MetroNews

Tuesday January 9, 2007

NEW Roman 'V'-Batten Bird-Stop flashing

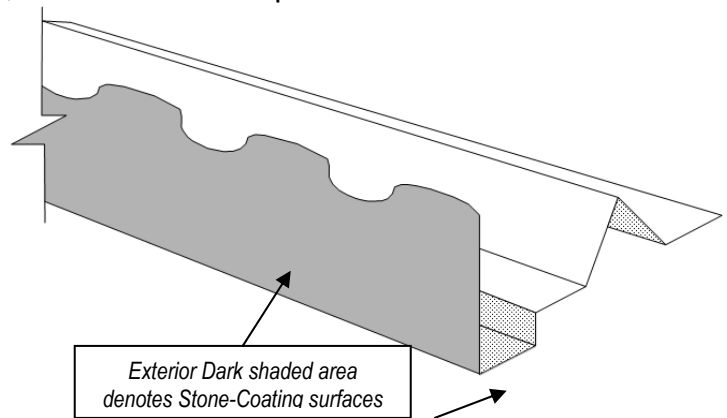
In response to contractor requests we have upgraded our Roman 'Bird-Stop' flashing with an integral batten.

The 'Roman V-Batten Bird-Stop flashing' now incorporates a panel support batten that eliminates the need for a costly 1X4 wood batten to be used across the fascia-eave to support the panel.

Because this new part uses substantially more metal, the price will be higher for this new version; however the new part eliminates the need for the fascia support batten and the labor to install it. The new Roman 'V'-batten Bird-Stop can now be installed with the other perimeter flashing prior to panel install so an underlay inspection can be requested.

ITEM	PART # - XX = Color	METRO INVOICE INFO
Existing Roman Bird-Stop Flashing	3135-XX	
NEW 'Roman 'V'-Batten Bird-Stop' Flashing	3134-XX	'Roman V-bat Bird-Stop'

Due to the differences between each part it's recommended that you do not mix the two in inventories or on job-lots.
